Re: **Request for Access to Records under the Freedom of Information and Protection of Privacy Act (the "Act")**

**In relation to Deputy Chief Building Official Kevin Lau's letter sent to the applicant on March 2, 2021, "...October 20, 2020, an interim position ...with respect to 'future installation of a low barrier shower' ...Sub-clause (b)(iv). This interim position has been provided to Housing staff management..." Request is for records related to the creation and approval of that interim position.**

# Adaptable Washrooms

Discussion with HAVAN 2020OCT20

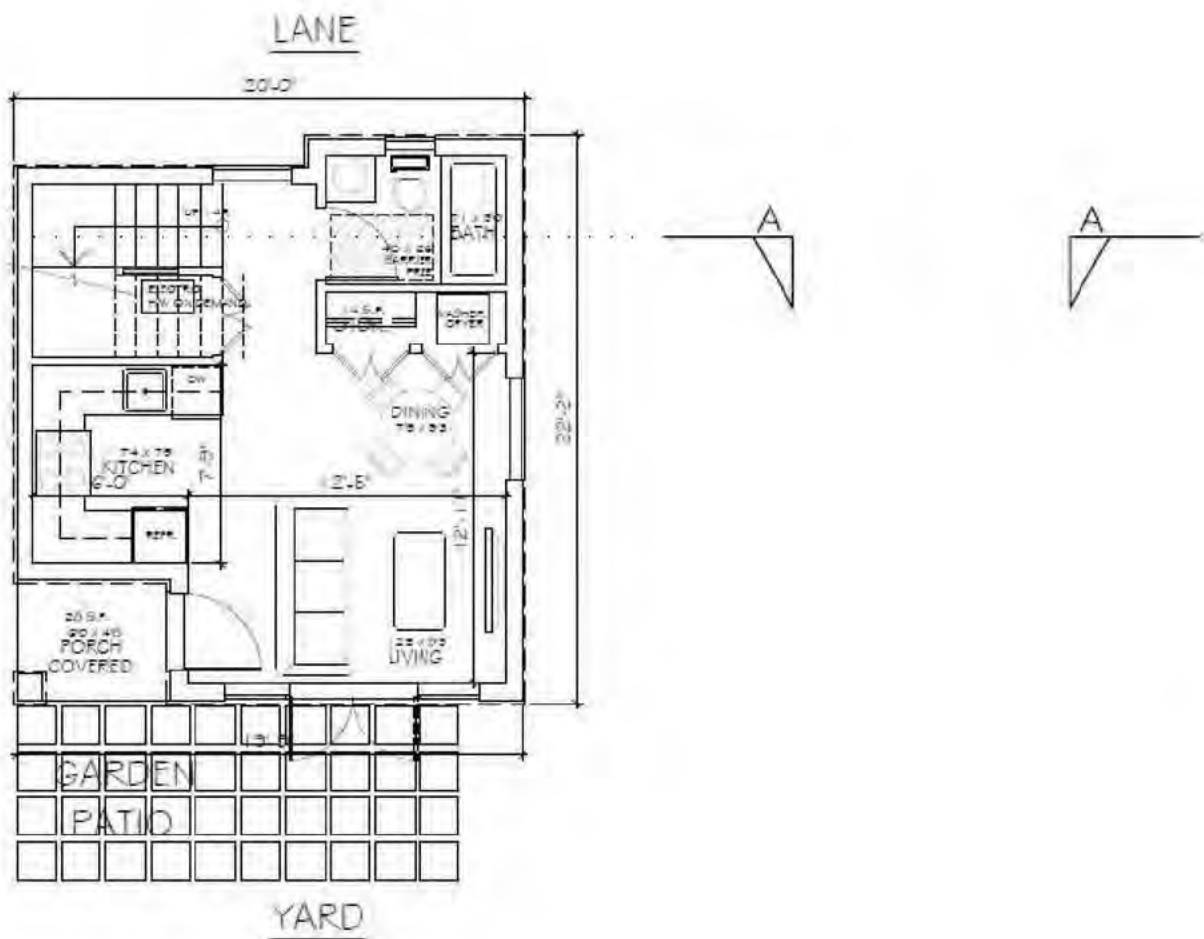
I have been accepting LWH ground floor consists of an attached garage, the floor area is approx. 200sf; so the adaptable bathroom on the second floor makes more sense when the second floor is much larger than the ground floor.

But I just received an inquiry about 1.5 LWH from James Kuhleitner (Khang's friend) if he reduces the ground floor from 430 sf to 388 sf; can he omit the adaptable bathroom.

He even sends me a layout that it can be accommodated on the ground floor, just doesn't really want to !

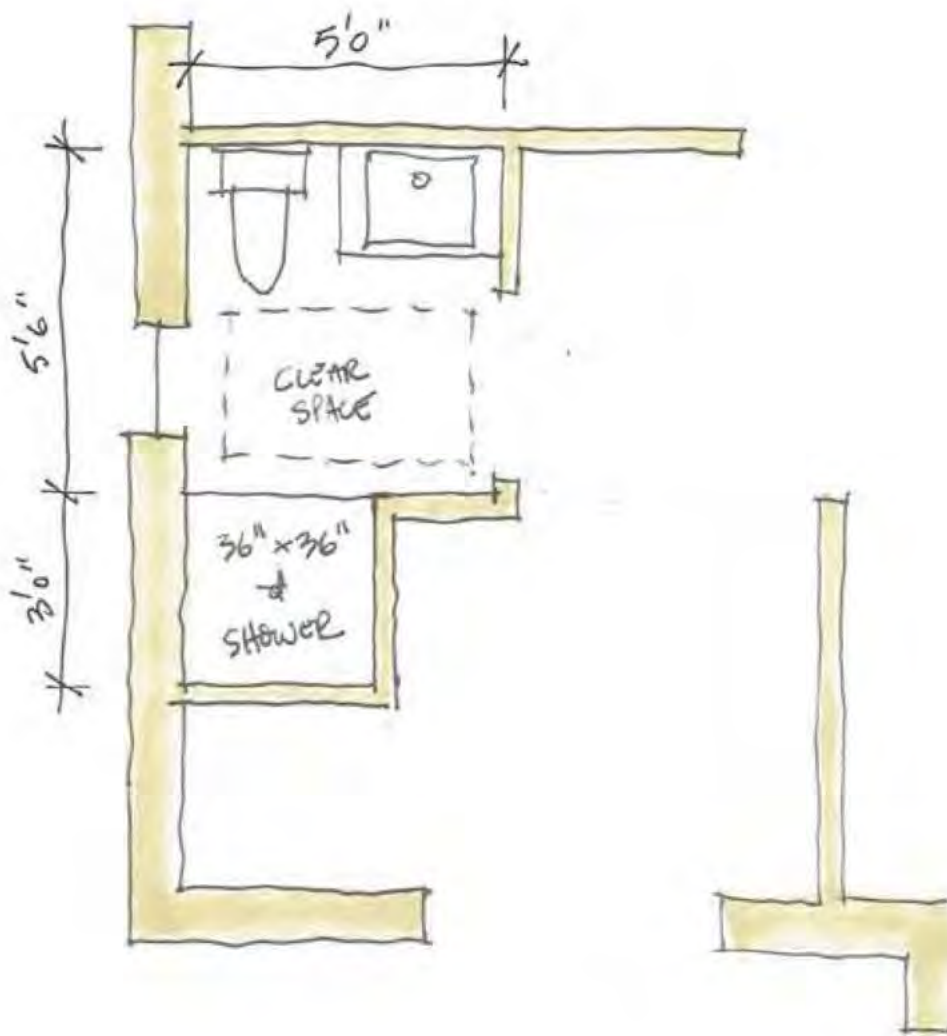
Ground Floor plan : approx. 950 sq. ft. ☐main house ☐main floor at entry foyer.

Here's the main house design in question.

The designer Alex Glegg was wondering if he is okay just to provide the space for the shower in the adaptable bathroom with a floor drain & rough-ins.

Yes, it is acceptable at the accessible floor level of a new 1FD building . Thanks again.  
We are currently working with our engineers at the CBO office to provide more guidance on this topic.  
As soon as we receive more information, we will make sure to forward the email to your office.

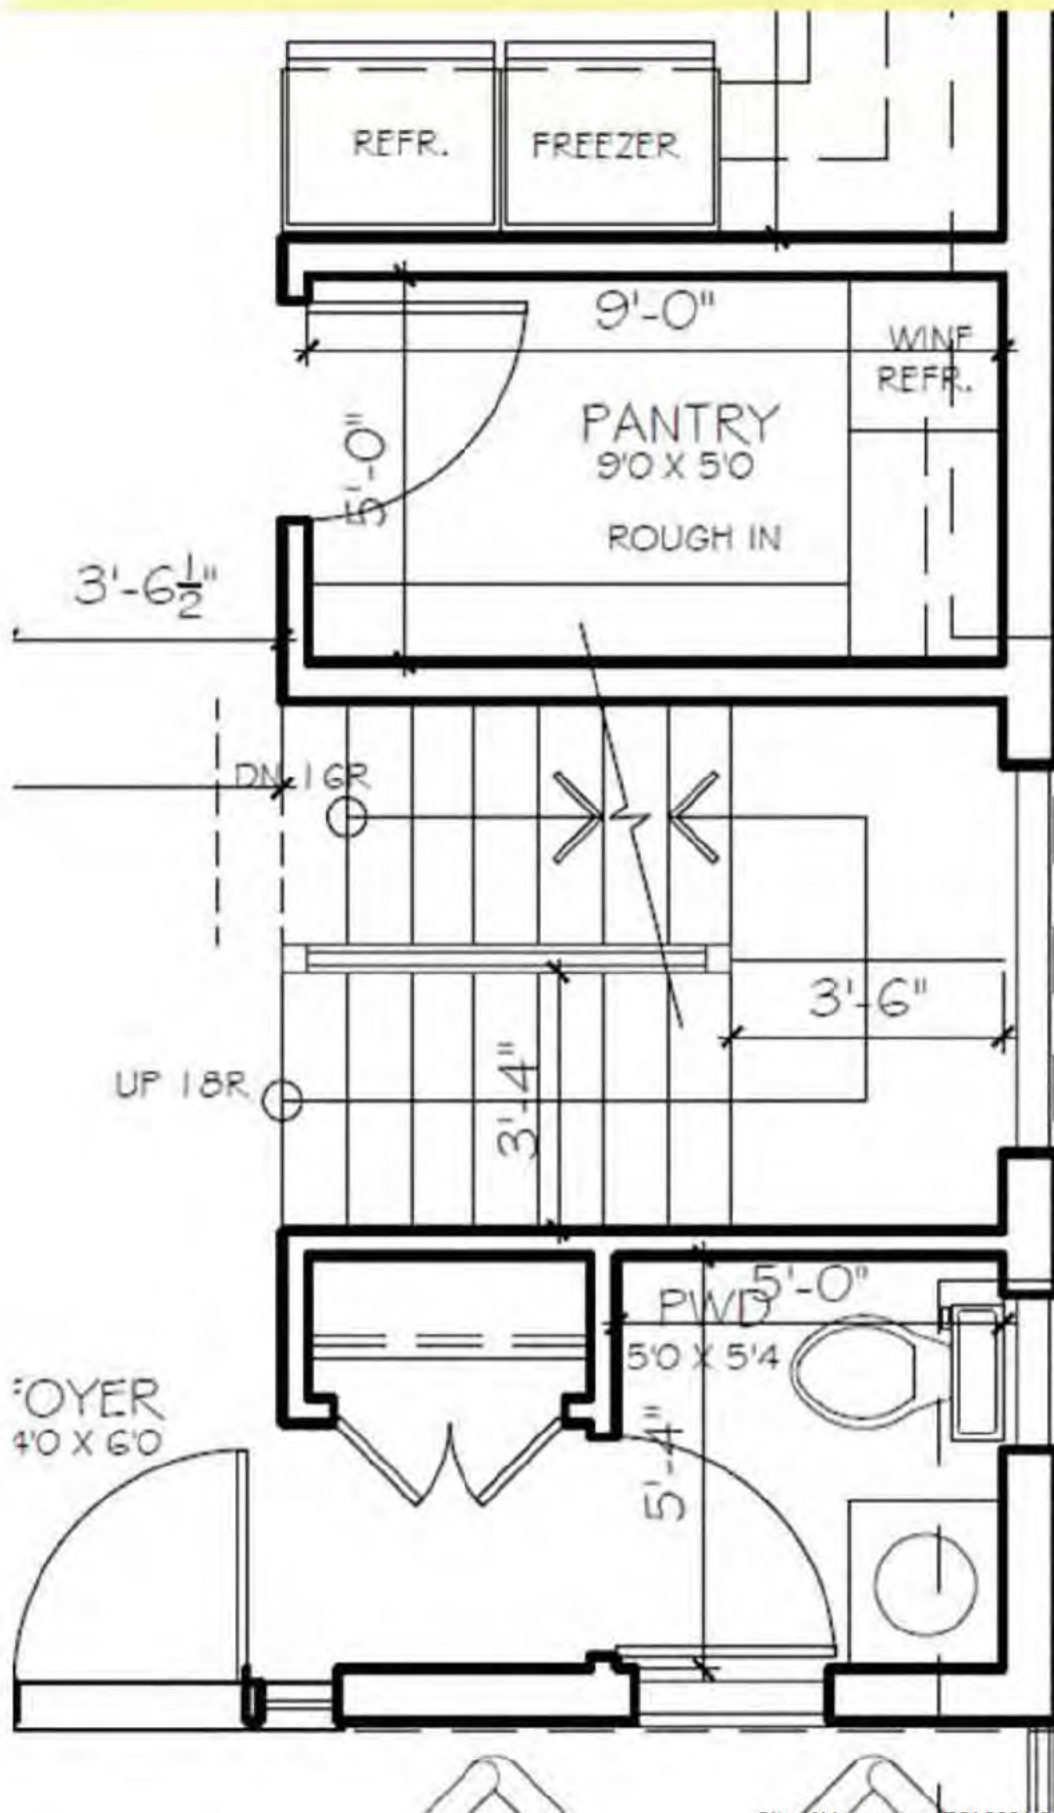
As you can see, we would plan on labeling rough ins for a bathroom and provide a drain in the pantry area. It is large enough to accommodate a full bathroom.

We have a client who wants a main floor with a powder room, however one that isn't large enough to provide a future shower. What we are proposing though is that we will provide rough ins for a future adaptable bathroom where we plan to design the pantry. We will have sink/toilet/shower rough ins and a drain all located in the pantry so that in the future it can be turned into an adaptable bathroom.

My question is: Is our proposal of rough ins for a future adaptable bathroom located in the current pantry satisfy the zoning guidelines for the city of Vancouver.

I think on this basis, I'd rather see some form proposal for the conversion of a space than can be added to the existing powder room.
